Marion County Subdivision Plat Review

Plat Title: River Gorge Ranch Phase 2 Final Plat

Date of Review	Reviewed by	Planning Staff
August 24, 2023	Ashley Gates	Renea Wilson

River Gorge Ranch Phase 2 Final Plat Lots 2001-2034,2229-2238

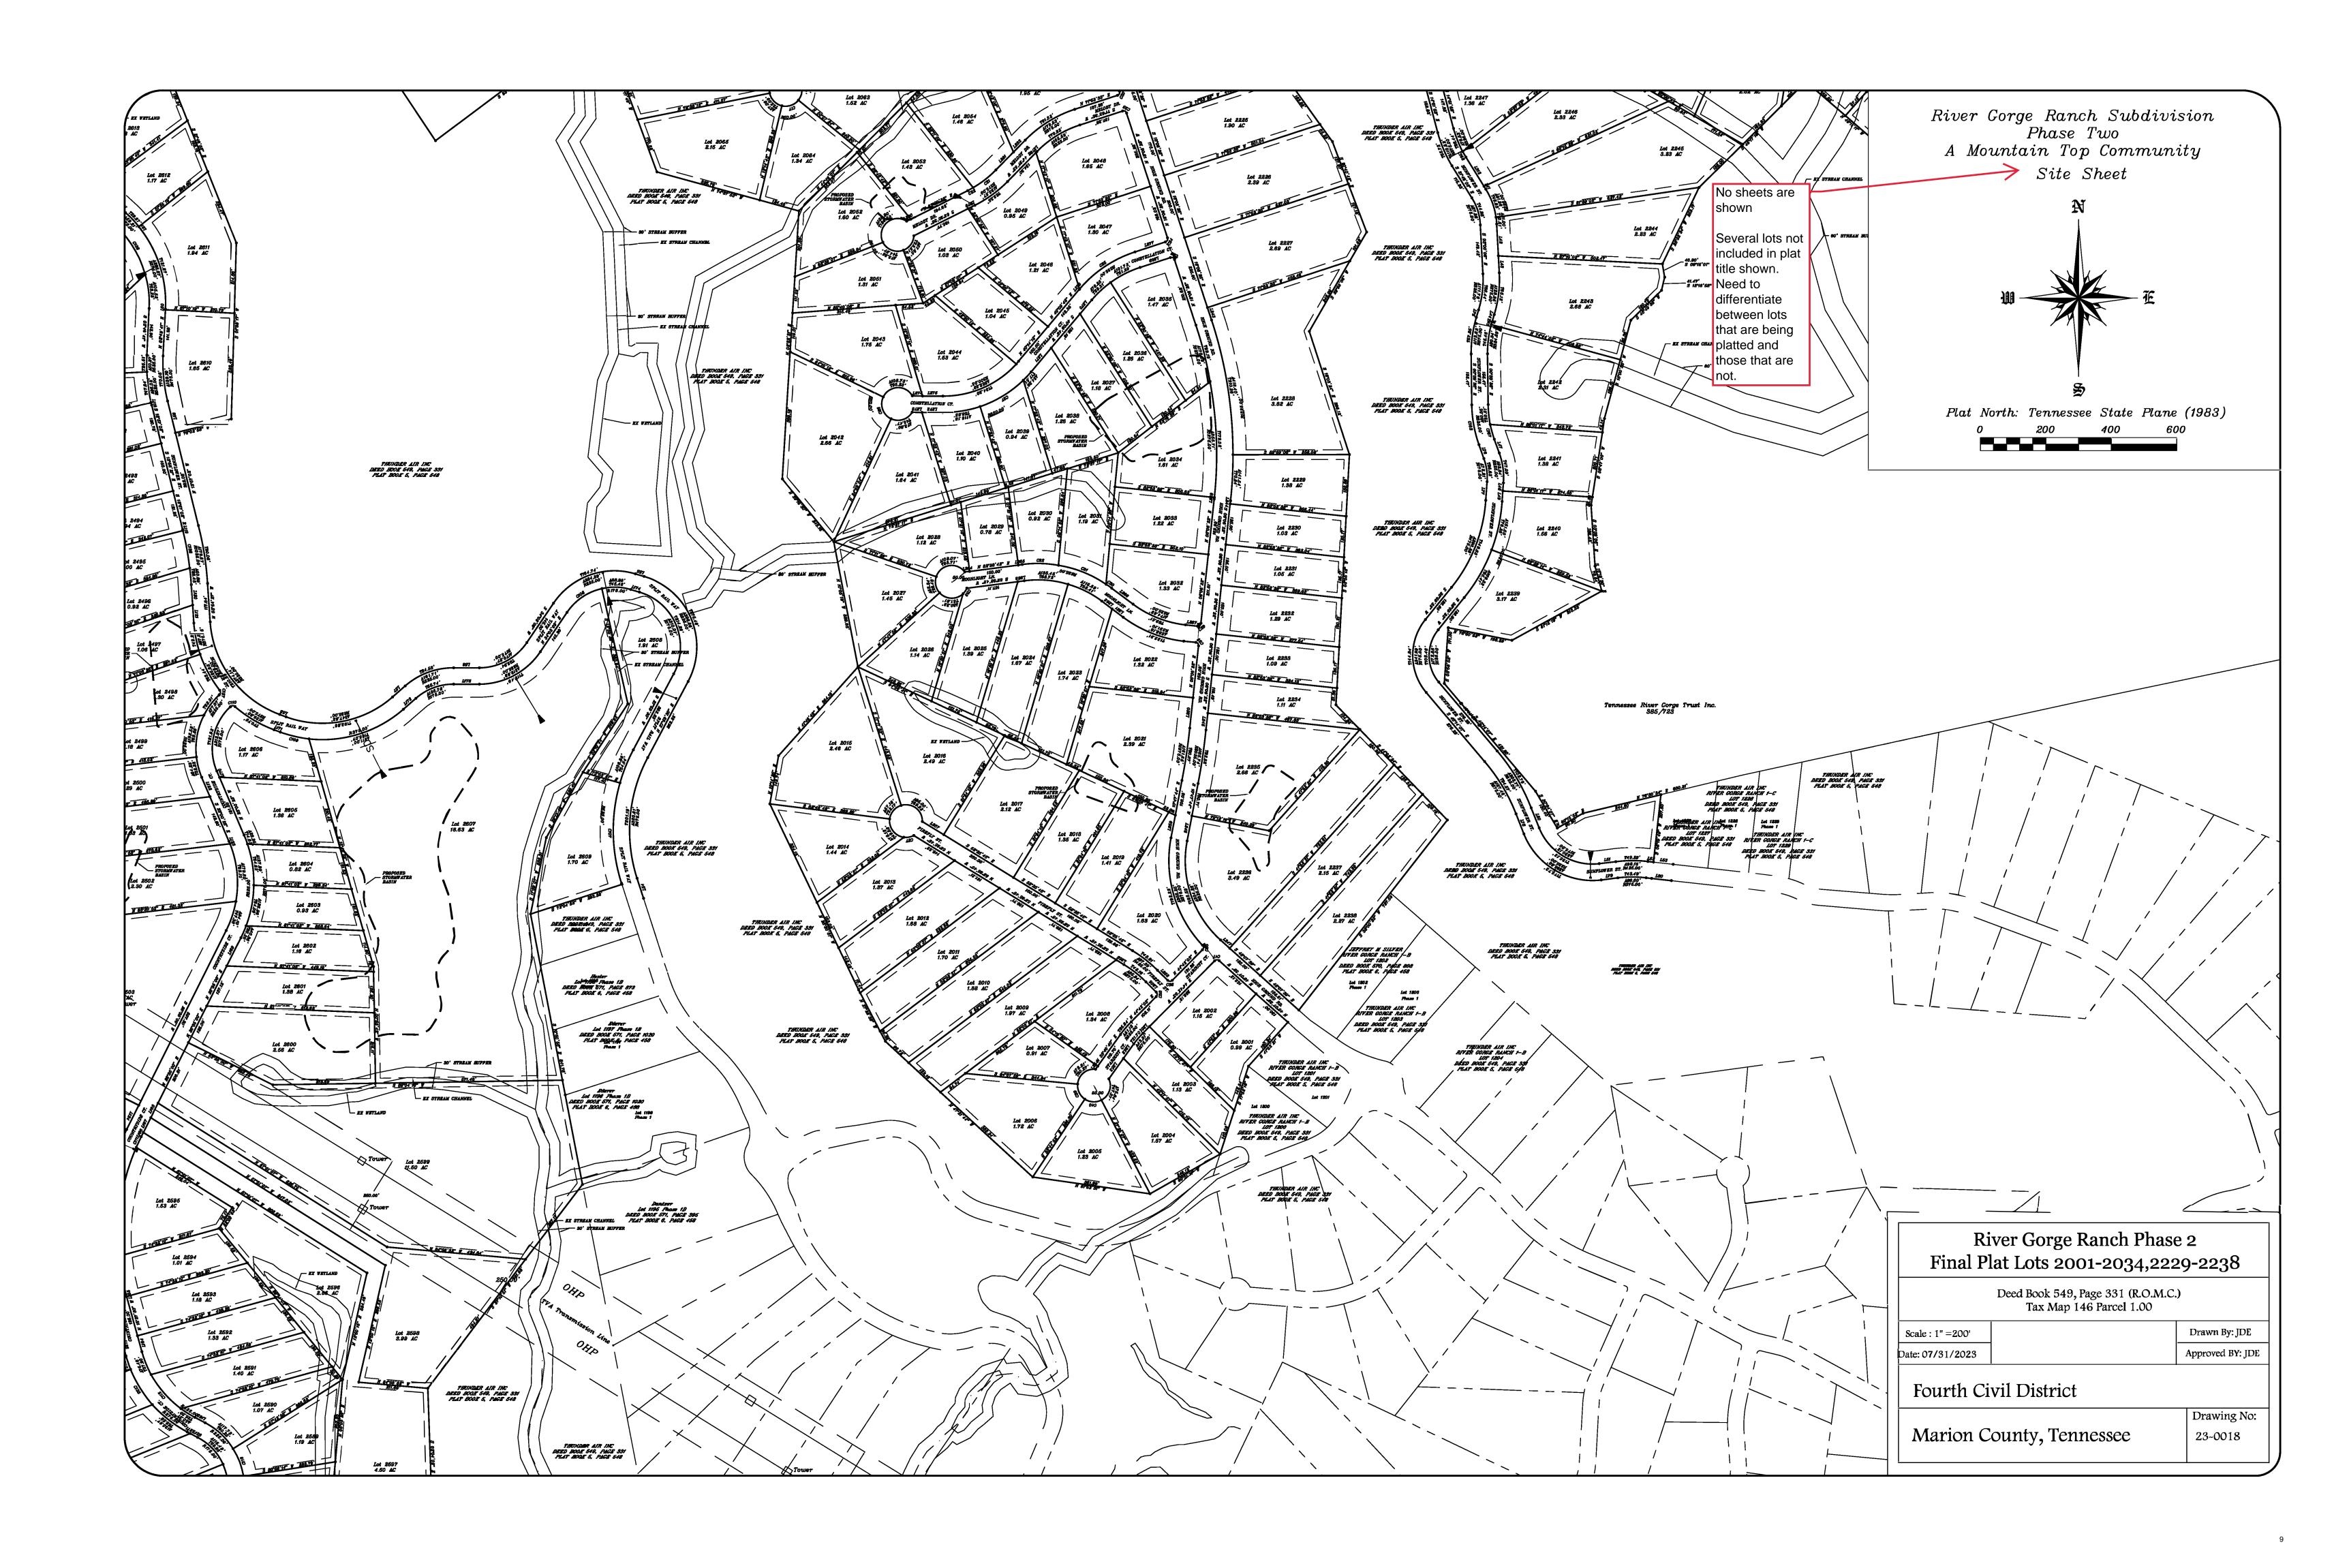
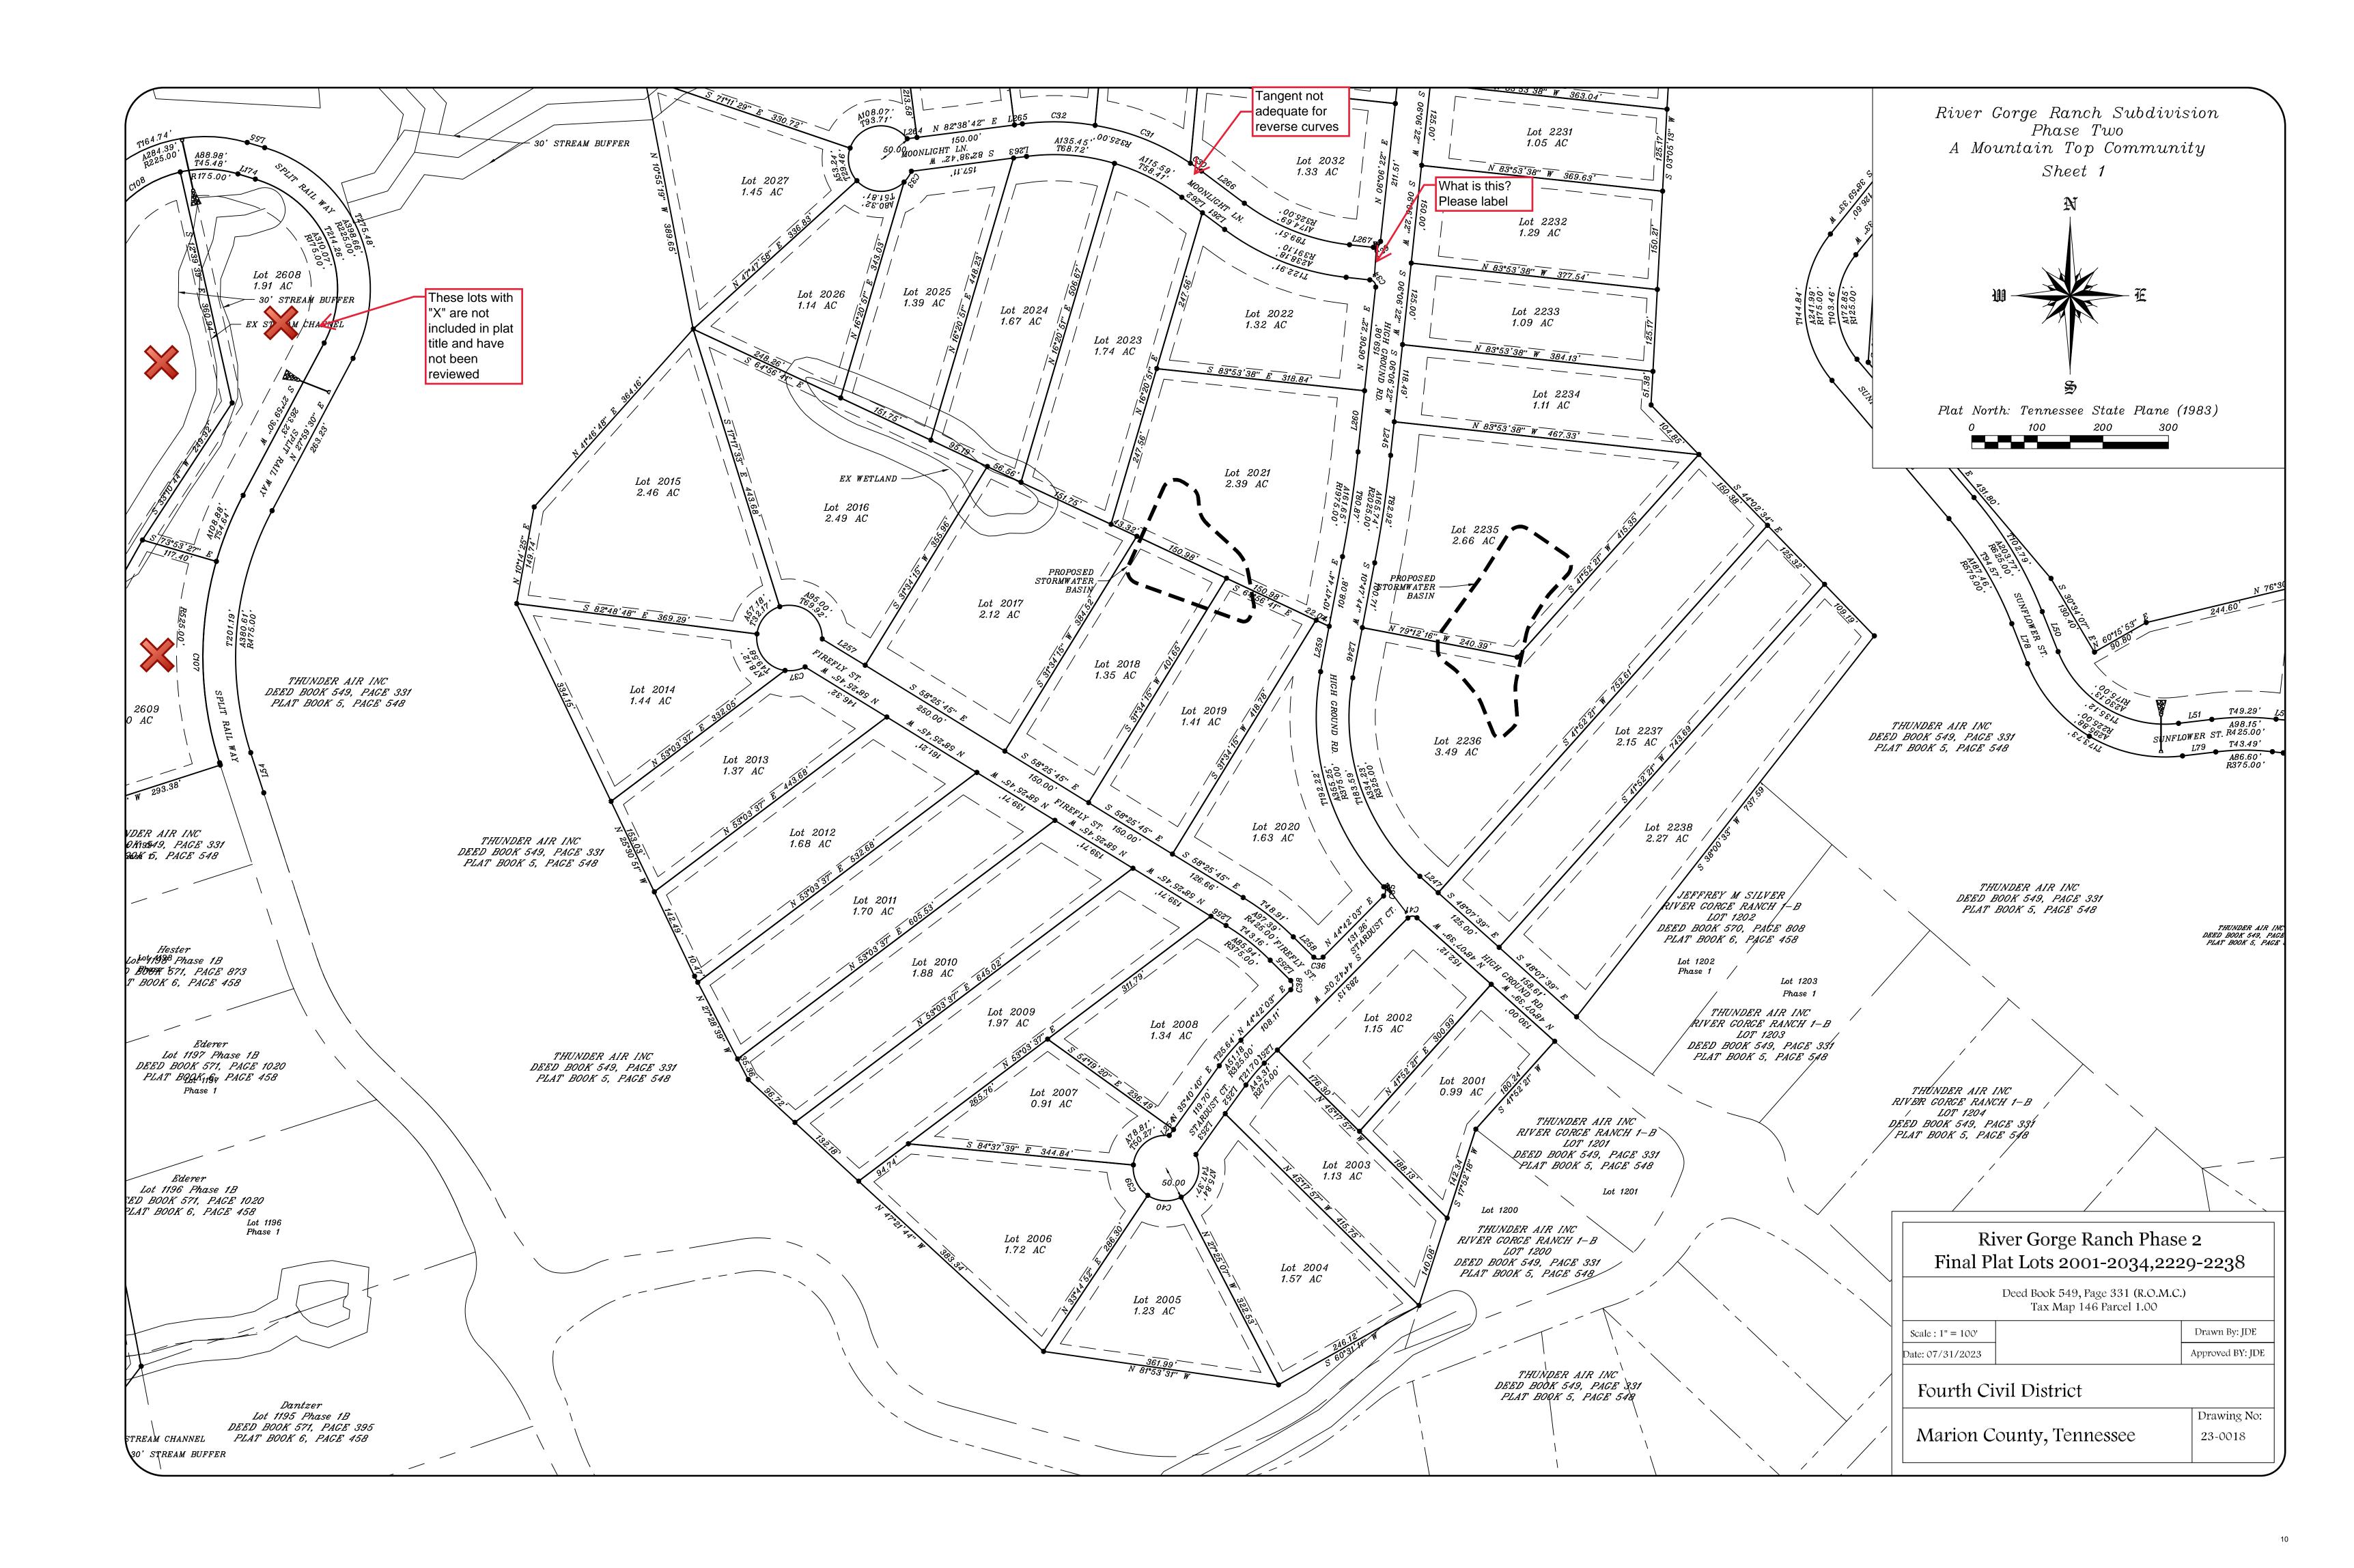
- Minimum Width: 75 feet at the setback line. All lots appear to meet this requirement.
- Minimum Depth: All lots appear to meet this requirement.
- Depth to width ratio: Depth must not exceed 5 times the width. Lot 2237 does not appear to meet this requirement. The Planning Commission may approve these lots if they find there are "unusual circumstances that make these limitations impractical." Approval of this plat constitutes approval of Lot 2237 as submitted. A separate motion is not required.

- Street Names: Appear to be High Ground Road, Moonlight Lane, Constellation Court, Firefly Street, and Stardust Court. Moonlight Lane is already in use within Jasper Highlands. Firefly Court is also in use in Jasper Highlands, which is similar to Firefly Street but not the same. Though they are different ZIP codes, staff recommends against repeating road names. Many who call 911 do not know which ZIP code they are currently in. The Planning Commission approves street names through plat approval, and may require changes.
- Right-of-Way width: Measurements were not provided, but based on spot checking by staff ROW appears to meet 50' minimum width for local streets and 50' radius requirement for cul-de-sacs.

- Temporary cul-de-sacs: No temporary cul-de-sacs are shown. Temporary cul-de-sacs are required at the end of any dead end streets.
- Horizontal Curves: Horizontal Curves must have a minimum centerline radius of 100 feet. No
 measurements are provided for centerline curves as required for final plats. Staff measurements
 indicate that all horizontal curves in this portion of Phase 2 exceed the minimum centerline radius.

- Tangents: Between reverse curves, a 100-foot tangent is required. The tangent between reverse curves on Moonlight Lane is not adequate.
- Vertical Curves: Vertical curves must provide a sight distance of 200 feet. Additional information for the vertical curve near Station 59 on High Ground Road is needed to ensure this requirement is met. All other vertical curves appear to meet this requirement based on the vertical profiles provided to staff.

Stormwater basins are shown on the final plat. No additional information regarding the drainage system is provided. Staff cannot assess compliance with this section of the Subdivision Regulations. Several roads exceed the grade limits listed requiring 3,000 PSI cement concrete.

- Differentiate between the lots that are intended to be platted and those that are not. Having them listed in the title is not adequate. Several lots are shown that are not listed in the plat title. Staff has not reviewed lots other than those listed in the title.

- List book and page number for any restrictive covenants that have been recorded.
- List all requested variances
- Select a different street name for Moonlight Lane

- Show temporary cul-de-sacs at dead end of High Ground Road
- Adjust Moonlight Lane to meet the required minimum tangent between reverse curves
- · Show road centerline with all required measurements

- Drainage easements should be listed or shown on plat
- Provide planning staff or Marion County Highway Superintendent with drainage plans so that compliance with Section 601 of the Subdivision Regulations can be reviewed.
